Re: Turkey Point Units 3 and 4  
Docket Nos. 50-250 and 50-251  
Response to Request for Additional Information (RAI) Regarding Alternative  
Source Term Amendment Request (TAC NOS. ME1624 and ME1625)

**Response to 12/17/2009 RAI Regarding AST Related Modifications**

Response to 12/17/09 RAI Regarding AST Related Modifications

Figure 1 – Planned Routing of CREVS Air Intakes

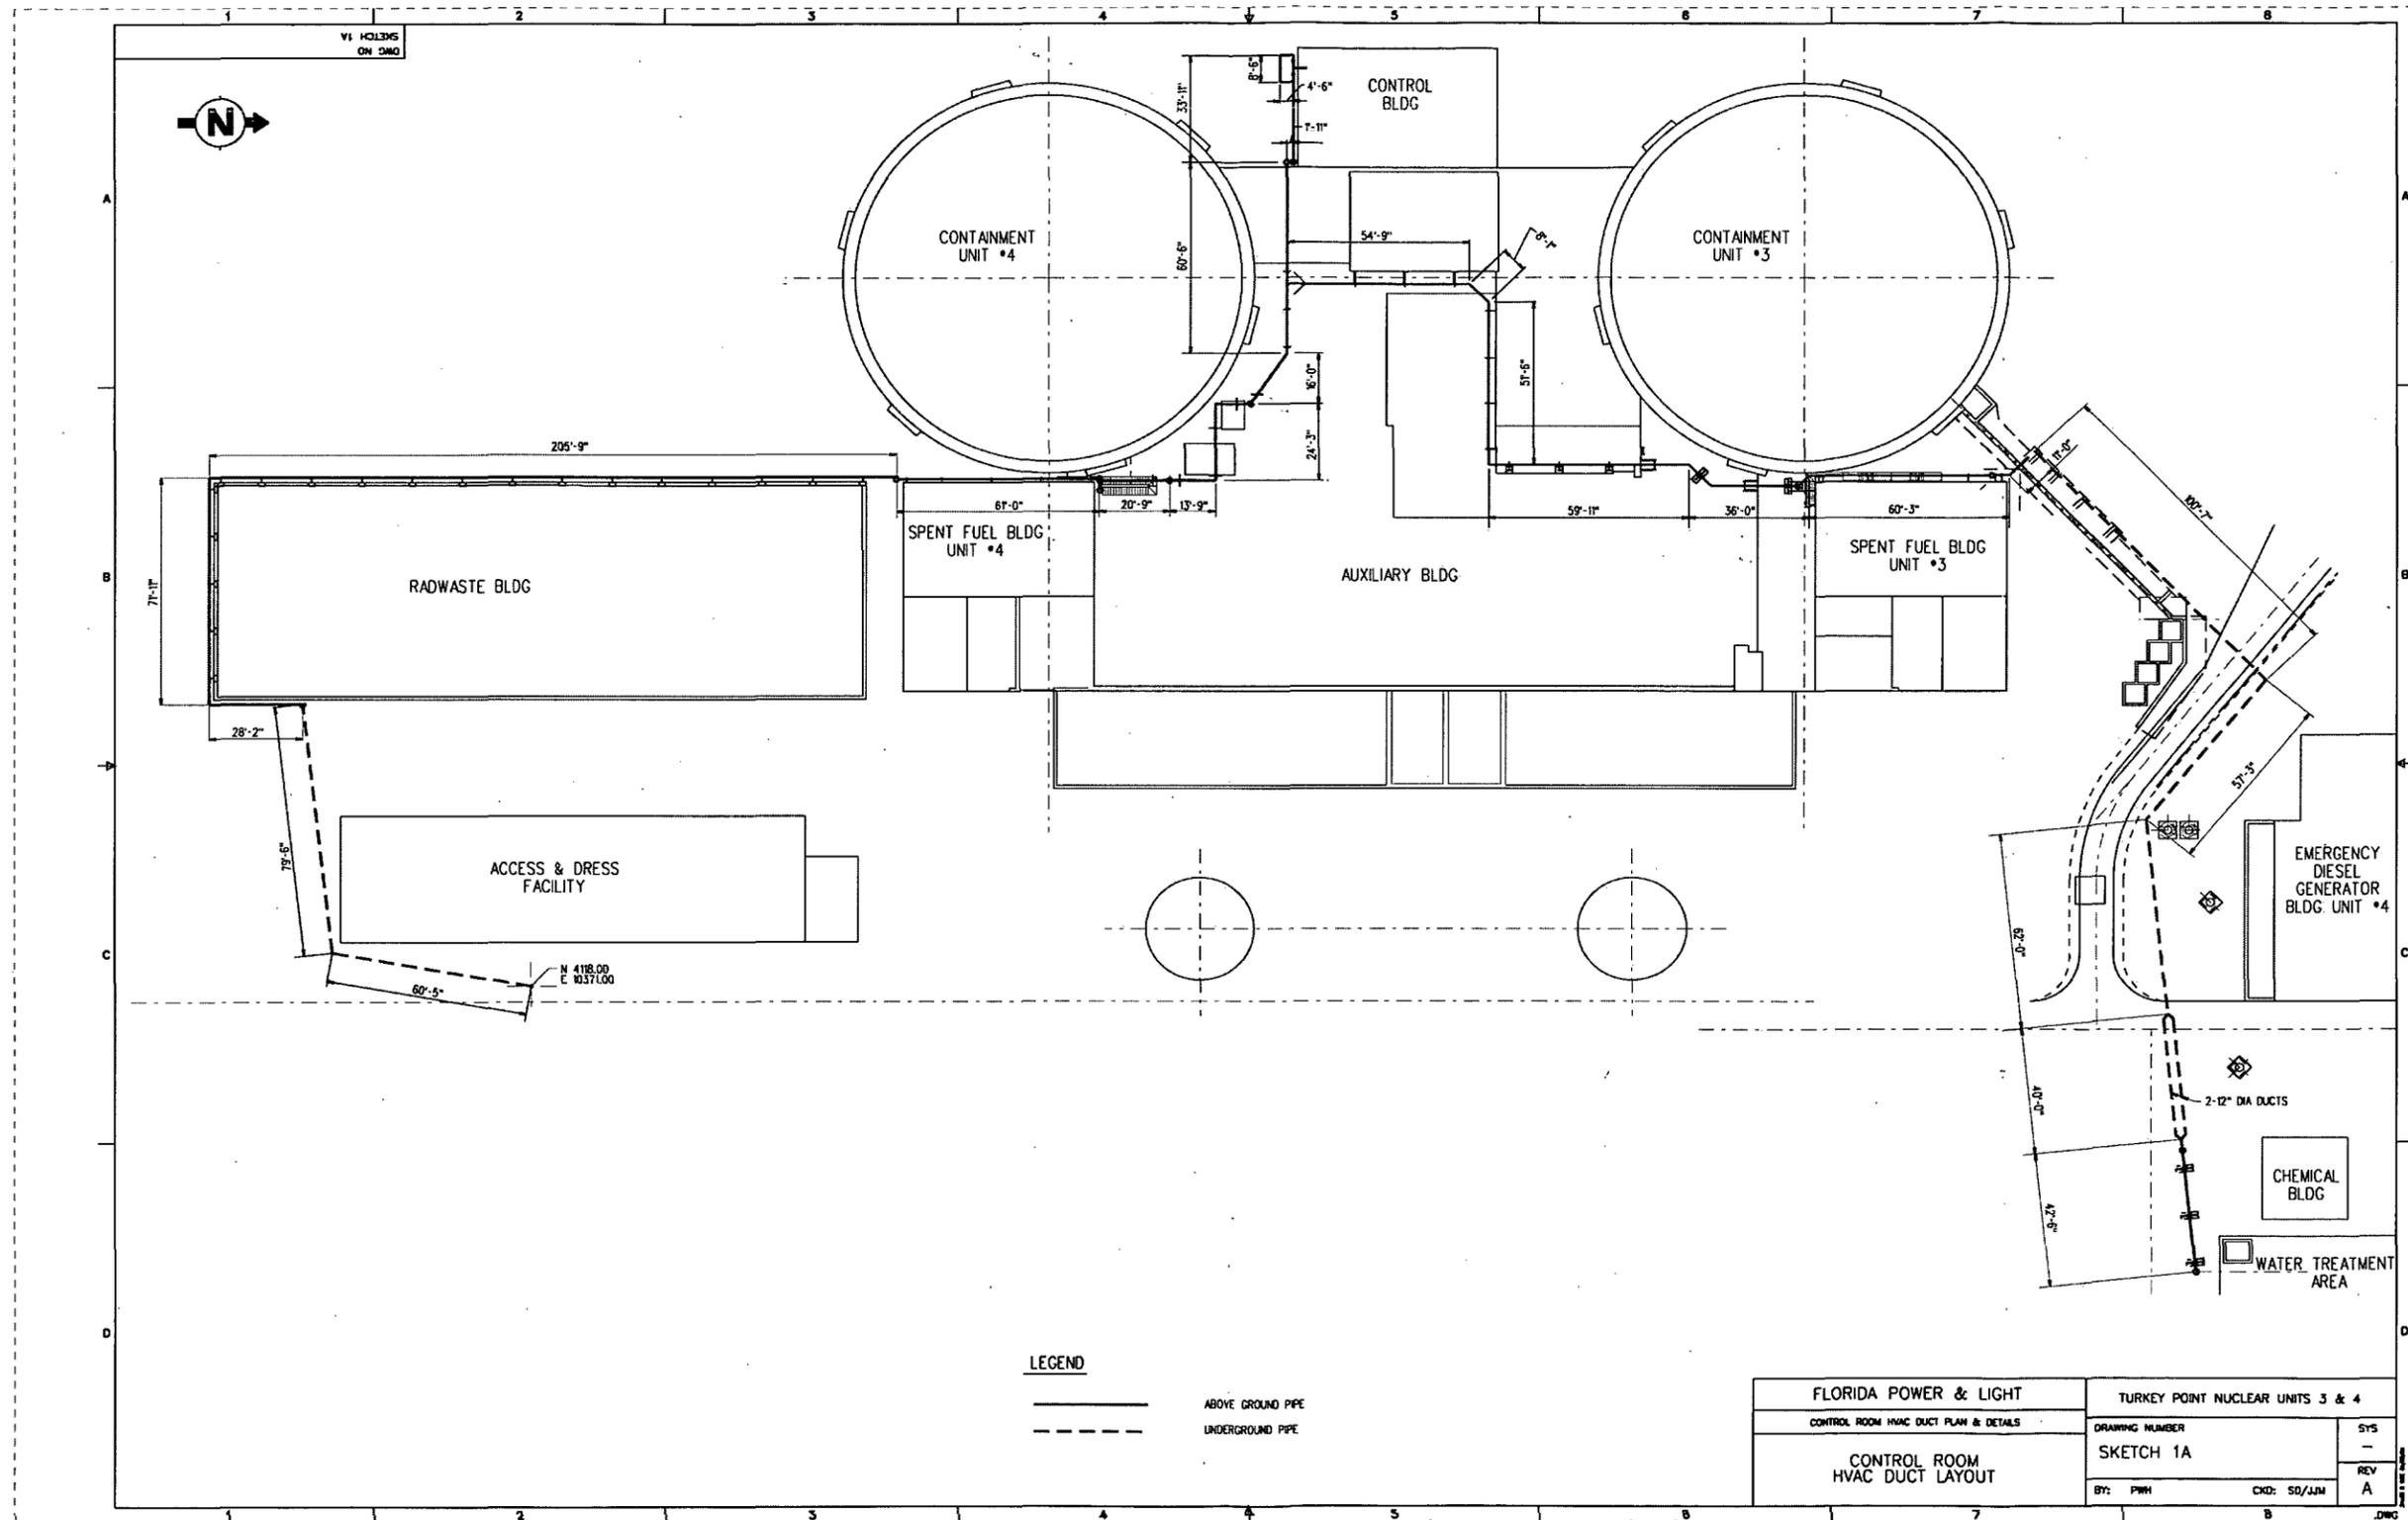
- a. Provide a sketch showing the relocated air intakes and duct work.***
  - b. Provide the results of the structural analysis of the relocated intake ducts and associated duct work, showing that the maximum stresses meet the design basis acceptance criteria under the safe shut-down earthquake and tornado loading.***

In order to achieve this, the new CREVS air intake duct routing is planned to be run from its penetration in the south wall of the mechanical equipment room along the control building wall and over the auxiliary building roof before splitting into two headers. The southeast header will continue around the Unit 4 containment building over the auxiliary building roof, along the Unit 4 spent fuel building and radwaste building roofs, then underground along the south and east side of the access and dress facility where it ends. The northeast header will continue around the Unit 3 containment building over the auxiliary building roof, along the Unit 3 spent fuel building roof, underground along the Unit 3 containment ramp, under the haul road, along the Unit 4 emergency diesel generator building, splitting into two parallel 12" headers to avoid interferences under the heavy haul road and then recombining into a single header again above ground just south of the water treatment area. See Figure 1 for the planned routing of the southeast and northeast air intakes.

Figure 2 – Planned Unit 3 Basket Locations

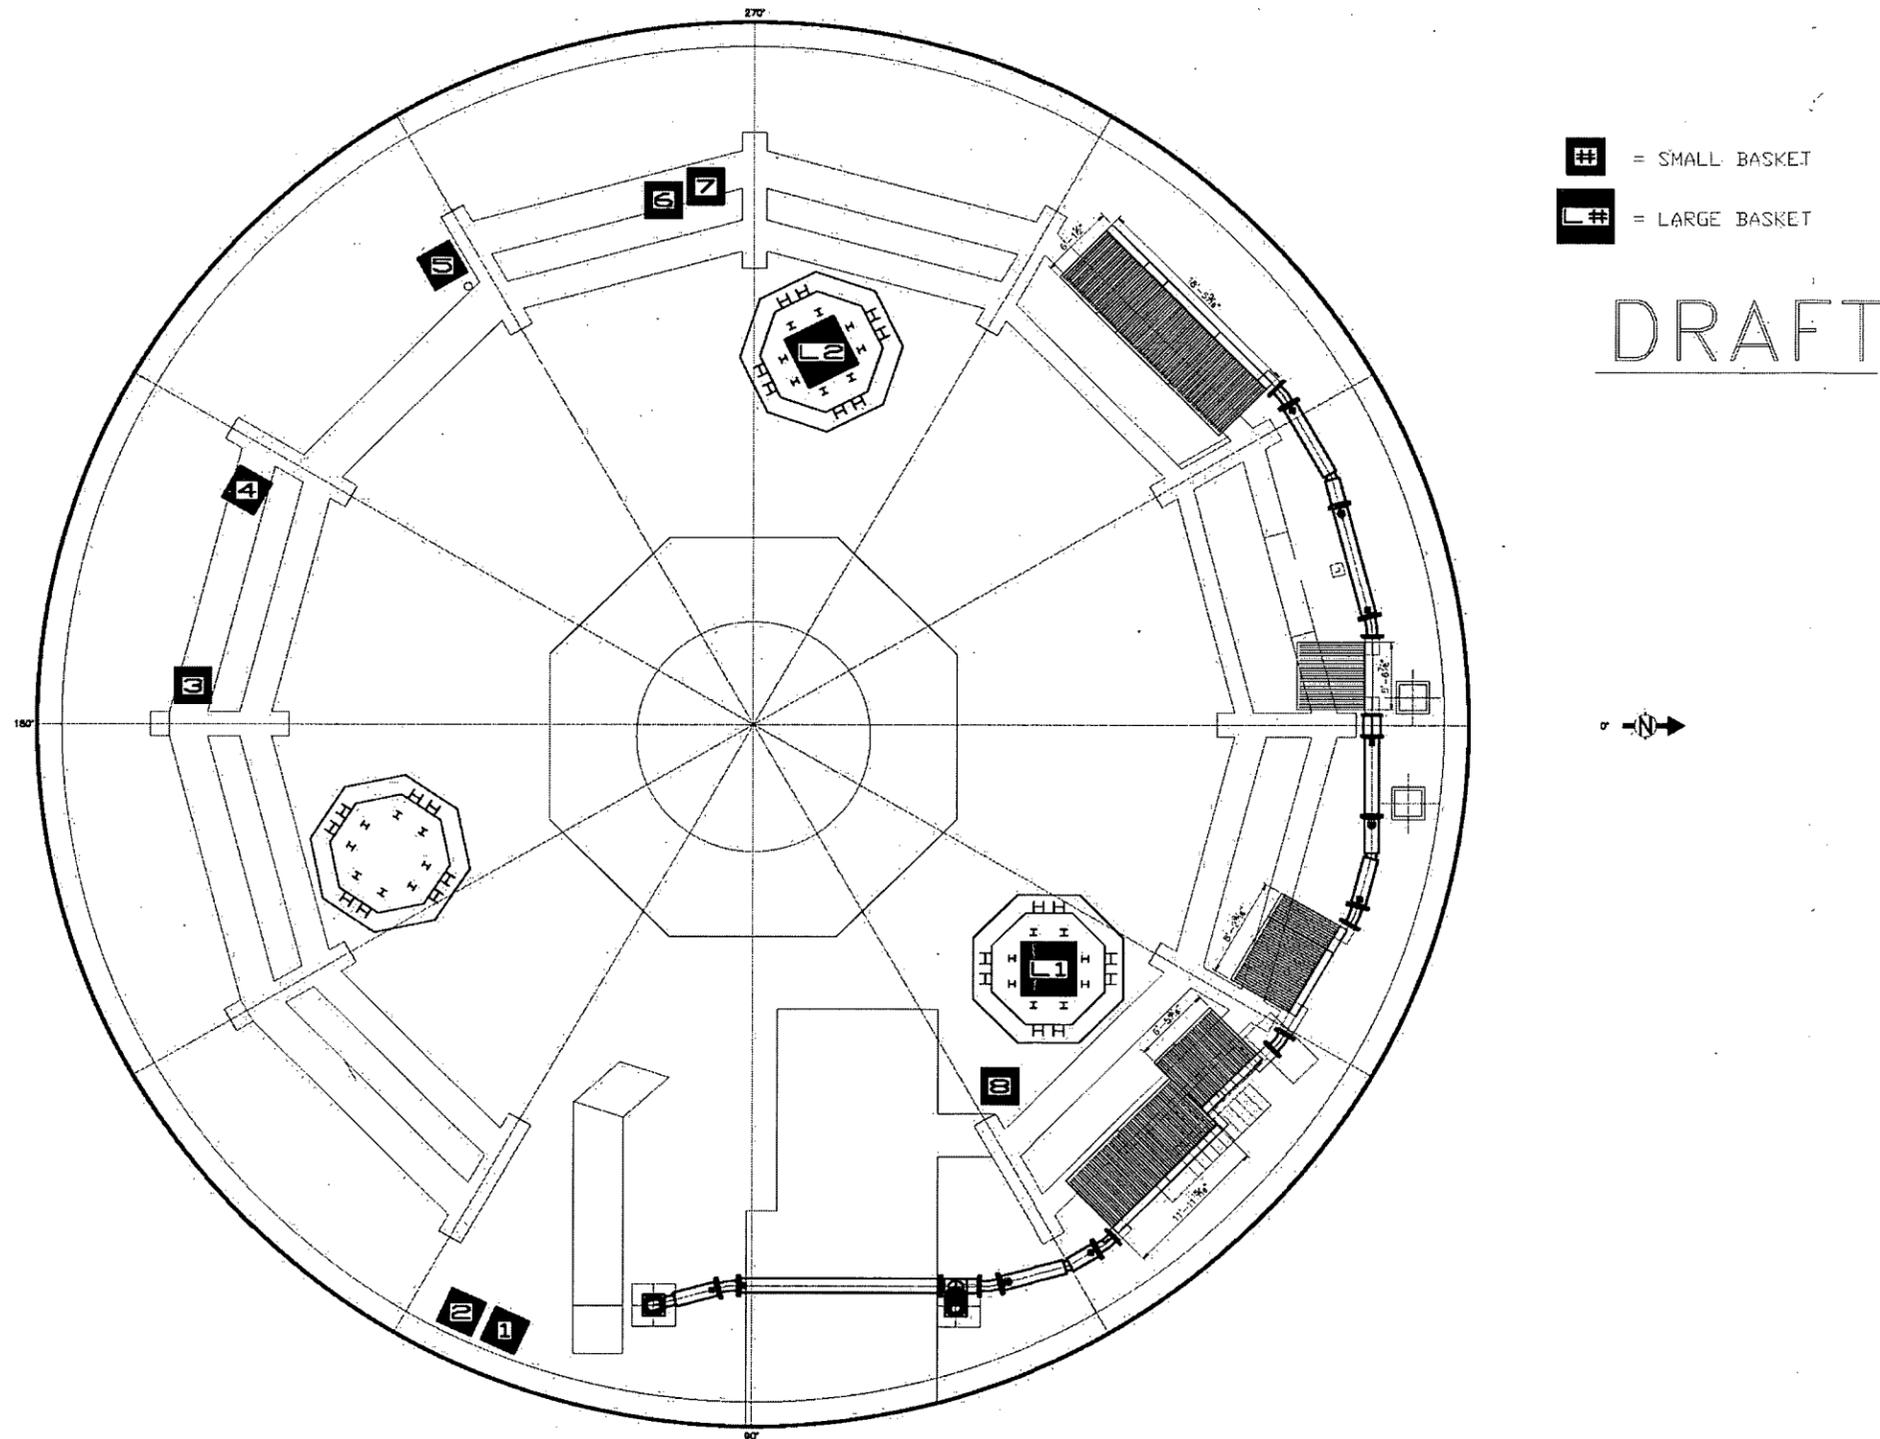
- 2. FPL stated on p. 14 of 20 of Attachment 2 to the Enclosure that it intends to install 10 stainless steel wire mesh baskets (two large and eight small) containing sodium tetraborate decahydrate (NaTB) in the containment basement, as a means of controlling the containment sump pH. These baskets contain a combined mass of 11,061 lbm of NaTB. Provide a detailed description of the structural design and analysis of these baskets, including the location, geometry, anchoring, the design loads and load combinations, design acceptance criteria and margins under normal and accident conditions.***

The basket locations have been chosen such that (1) the baskets will avoid seismic interaction with safety-related SSCs, and (2) the baskets will be out of the zone of influence of any potential High Energy Line Breaks (HELB). Based on the current design, the eight small baskets will be located outside of the biological shield wall (with the exception of basket #8 in Unit 3) while the two large baskets will be located within the shield wall in each unit. See Figures 2 and 3 for basket location details for Unit 3 and Unit 4, respectively.
